Product Change Notification

1. ECR #: 221065
Notification #: 669

3. Series:
• 135 - 1.35MM COMPRESSION MOUNT STRIPLINE

4. Part #'s Affected
• 135-J-P-VP-ST-CM-X-X

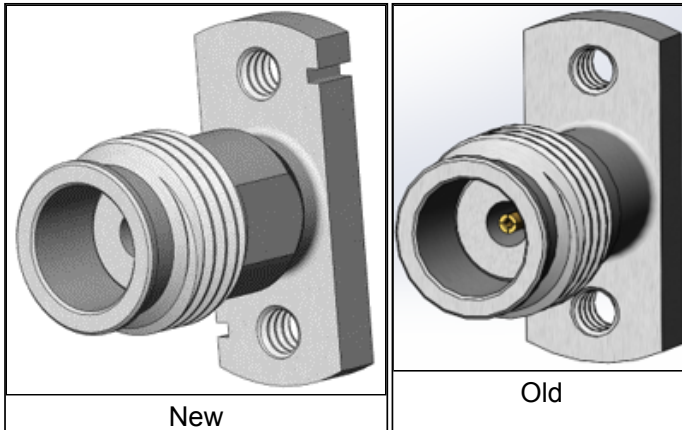
5. Description of Change:
We added two grooves on our body for PCB mounting alignment and a flange for our custom wrench to prevent rotation.

6. Method of Identifying Change
Two grooves and a flange on the new body

7. Reason for Change:
For better alignment onto the PCB

8. Impact of Change on Form, Fit, or Function:
• Form - Form change
